Revision: Issue 1
Date: 9th February 2015

Lida Textile & Dyeing Ltd.

Structural Inspection Report

Observations & Actions

Lack of edge protection

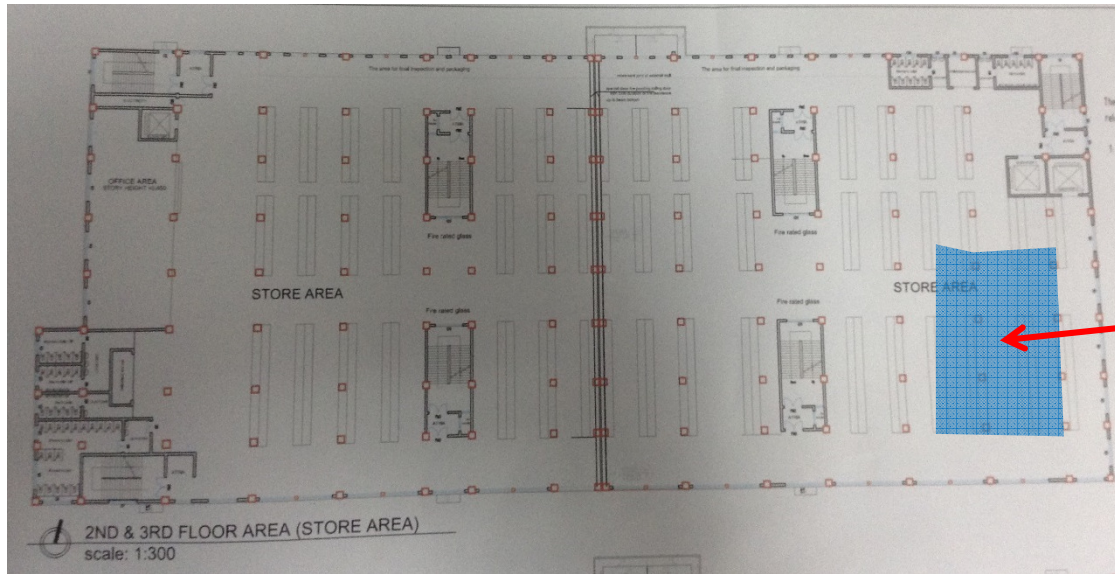
We also have concerns regarding the lack of guarding/edge protection at the highest roof levels (roof to offices). **Appropriate edge protection should be provided immediately.**

**No edge protection was provided on the roof
over office areas**

Floor Loading

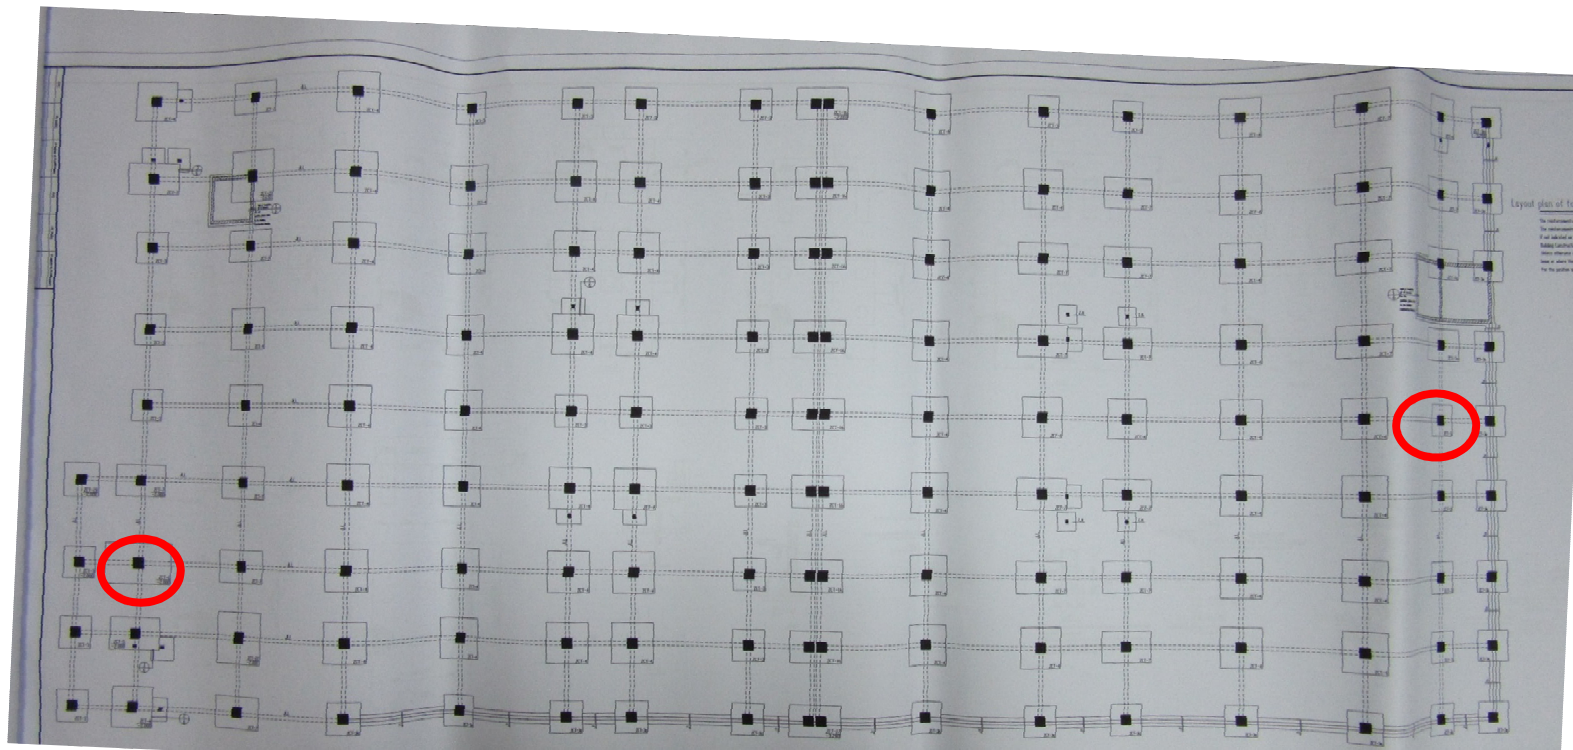
Observed loading varied up to 3.6kPa on 2nd and 3rd floors

Area of localised 5.5kPa loading at 2nd floor

Maximum imposed floor loading shown as 6.15kPa on wall at First Floor.

- Building Engineer to prepare Loading Plans for each floor of the building based on column capacity and beam/slab capacity.
- Comply with the loading on each floor as specified in the loading plans

Column testing

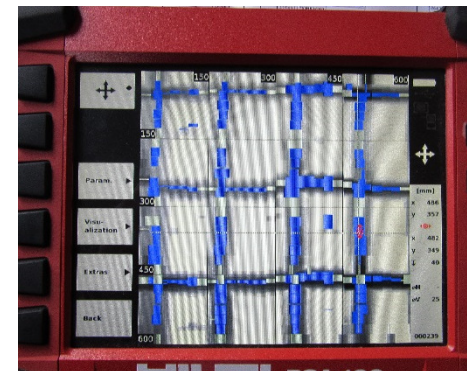
Site measurements and observations correspond to drawings.
